Access Compliance Report Public Rights-of-Way (Curb Ramps)

Intersection ID: 23740 Main Street: PARK_RD Cross Street: SMITHFIELD_CHURCH_RD Location: SE

ADA ID: 2499D72F7175 Ramp Type: PerpDiag Initial Pass/Fail: Fail Overall Compliance: No Severity Score: 25

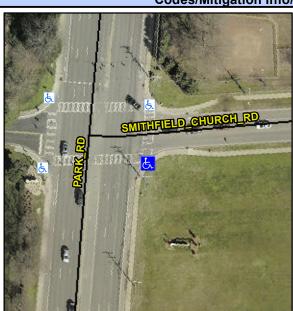
R304.2.2, R304.5.3

Compliance Description		Data		liance Description	Data
N/A	Ramp Length (in)	60.0	No	Ramp Slope (%)	9.9
Yes	Ramp Width (in)	48.0	No	Ramp XSlope (%)	5.6
N/A	Flare Type LT	N/A	N/A	Flare Type RT	N/A
N/A	Flare Slope LT (%)	N/A	N/A	Flare Slope RT (%)	N/A
N/A	Flare Traversable LT?	N/A	N/A	Flare Traversable RT?	N/A
N/A	Landing Length (in)	N/A	N/A	DWS Provided?	N/A
N/A	Landing Width (in)	N/A	N/A	DWS Contrast?	N/A
N/A	Landing Slope (%)	N/A	N/A	DWS Length (in)	N/A
N/A	Landing X Slope (%)	N/A	N/A	DWS Full Width?	N/A
N/A	Landing Curb? (Y/N)	N/A	N/A	DWS Offset (in)	N/A
N/A	Shared Landing?	N/A			
N/A	Gutter Ponding?	N/A	N/A	Gutter Slope (%)	N/A
N/A	Gutter Lip Ht (in)	N/A	N/A	Gutter X Slope (%)	N/A
N/A	Painted X Walk1?	Yes	N/A	Painted X Walk2?	Yes
	X Walk 1 Direction	To NE		X Walk 2 Direction	To NW
N/A	X Walk 1 Width (in)	109.0	N/A	X Walk 2 Width (in)	101.0
	X Walk 1 Slope (%)	1.5		X Walk 2 Slope (%)	5.4
	X Walk 1 X Slope (%)	6.7		X Walk 2 X Slope (%)	0.1

Remove & Replace Curb Ramp With
Two New Directional Ramps or
Equivalent.
